NRG Knit Composite (9359)

Enayetnagar, Bholail, Fatullah, Narayanganj

08.July.2014

Identified Priority 1 Concerns

1st Priority 3 Concern

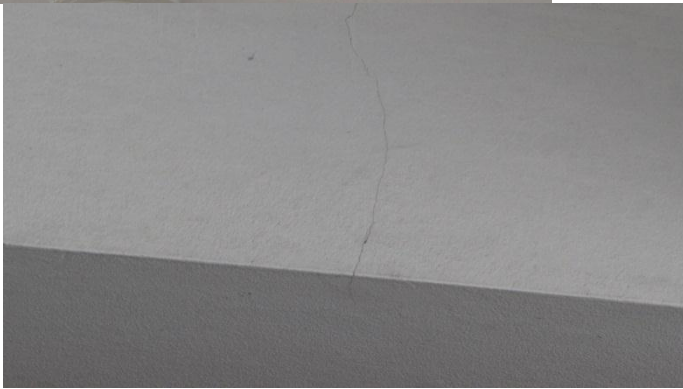
There are signs of water penetration at the underside of roof floor. The reinforcement in this area of the concrete floor could have already started to corrode. This could potentially lead to the failure of certain members

4	1st Priority 3 - Lack of proper waterproofing or poor construction on the roof level resulting in significant water damage on walls, ceilings and beams.	Provide propping to the damaged concrete areas (slab, beam and column).	6-weeks
5	1st Priority 3 - Lack of proper waterproofing or poor construction on the roof level resulting in significant water damage on walls, ceilings and beams.	Apply a proper waterproofing system to the roof floor level. Hack away the damaged concrete and expose reinforcement to check for corrosion Carry out replacement of reinforcement and proper repair of the structural elements.	6-months
6	2nd Priority 3 - There are many cracks on the ceiling, beams on all storeys of the building.	Carry out full survey of all structural elements and check for compliance with BNBC codes to figure out the reasons of crack formation (due to under design or poor construction)	6-weeks
